SUBJECT: ALLEGATIONS CONCERNING SEABROOK
(BOARD NOTIFICATION 83-121A)

Document Name:
BN 83-121A

SUBJECT: EVALUATION OF SEABROOK ALLEGATIONS (TAC #141431)

SUBJECT: TRIP REPORT SUMMARY FOR SEABROOK ALLEGATIONS

FIG. 1

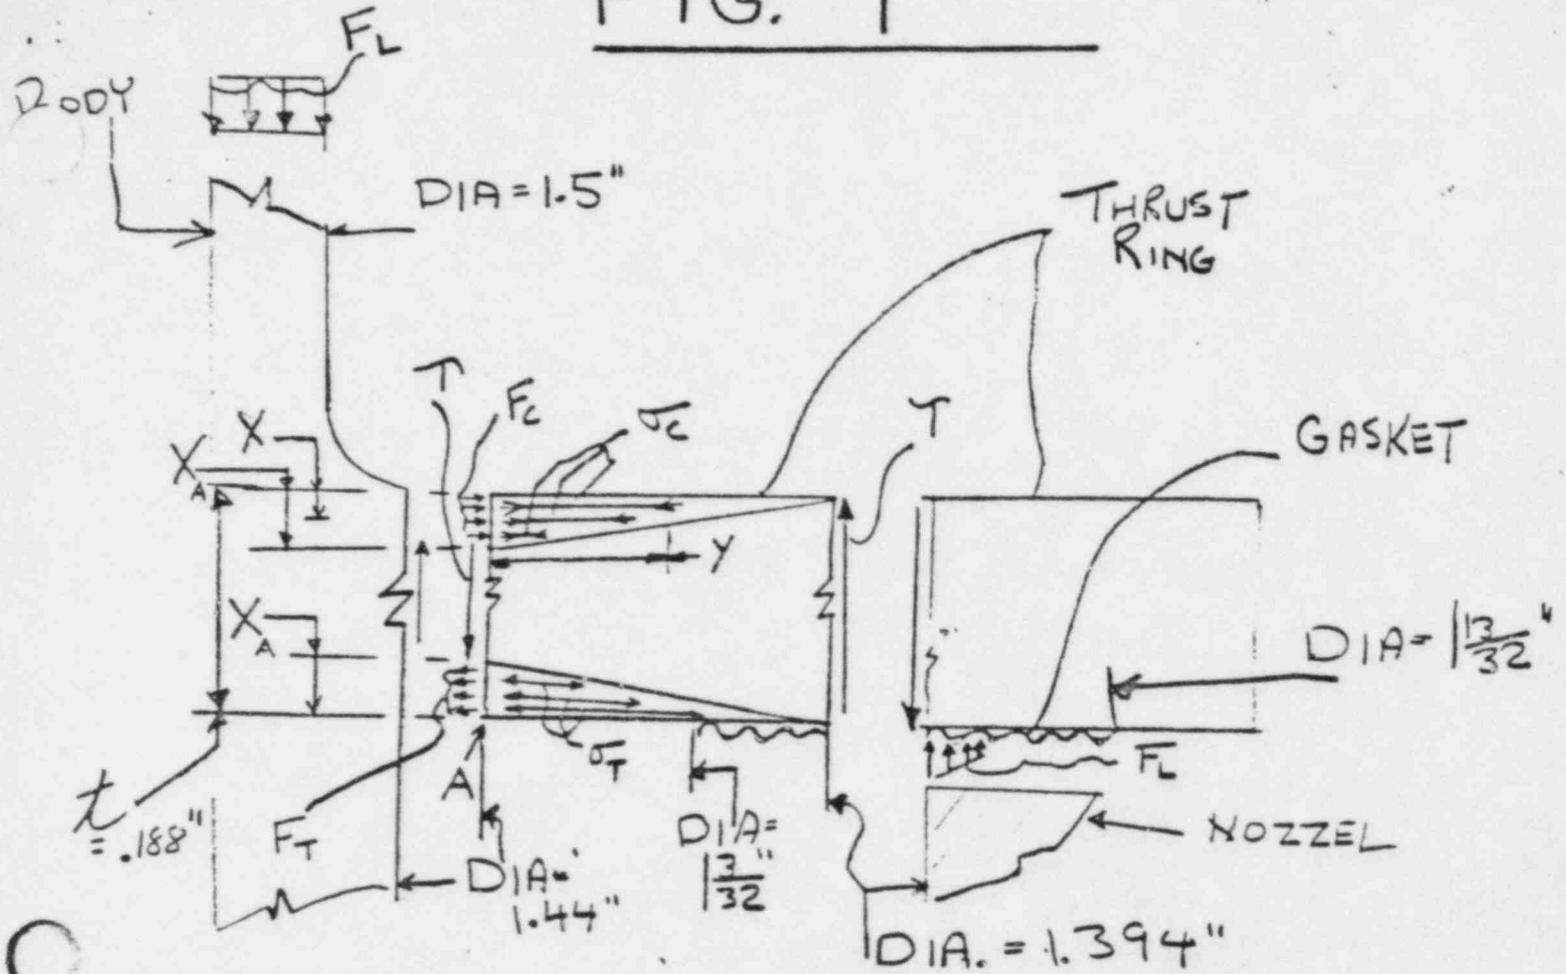
Regarding point number 5, above, based on the length to height ratio of the thrust ring in question, the model which I used from Roark, Formula of Stress and Strain, was an oversight and is apparently inappropriate. I have not been able to check this in Roark, however. I have examined the possibility of transference of this load via a pure shear panel mechanism, radially, across the ring. I have used optimistic assumptions in the attached calculation, which are as follows:

- a. Diameters for the effective end points of the beam. The points of effective force application could vary from $Dia.=1.394$ to $Dia.=1.294$, or so, depending on the distribution over the gasket. (Fig. 1, Attached) The load, F_L , can not enter the body wall as a vertical compression force within $Dia.=1.5$.

- b. CONSIDERING VARIANCE OF γ AND Y (FIG. I) WITH DIAMETER, σ_T AND σ_C MIGHT INCREASE TOWARD X_A , AND THE MOMENT ARM, $(z - X_A)$, MIGHT BE SMALLER.
- c. The tangential transference of this load has not been considered.
- d. The necessary bias of this load toward the valve outlet side, across the valve inlet crosssection, has not been considered.
- e. The gasket load is neglected.

The stresses seem lower with this calculation, but I still think it would be a good idea to analyze this situation further, and use the computer if necessary. If the load in question travels across the thrust ring via a combination of the beam bending mechanism of my original analysis and the pure shear mechanism of this analysis, this would be in agreement with my calculations. σ_C and σ_T are compression and tension stresses at the top and bottom of the thrust ring, necessary in allowing it to function as a shear panel. These are necessary since, in this case, there are no means of horizontal resistance, above and below the ring, to resist the moment generated by the transference of the shear. I have assumed σ_T and σ_C equal to 28,000 PSI, the particular material yield stress. I have solved for X_A equal to the vertical distance at Dia. = 1.44, necessary to accommodate σ_C and σ_T , which are assumed uniform; and for the shear stress at Dia. = 1.44. It is 13,135 PSI. Please check my arithmetic and assumptions, if you will. ~~If σ_C and σ_T are assumed to be nonuniform and X_A therefore, less, the outer fiber stresses are larger and shear is present within this region.~~ If the area of the ring, less inner diameter than the point of force application, is assumed to aid in resisting σ_C and σ_T , a moment associated with this resistance must be transferred outwardly to the body, through the ring, within the shear panel area, and affecting all areas' stresses.
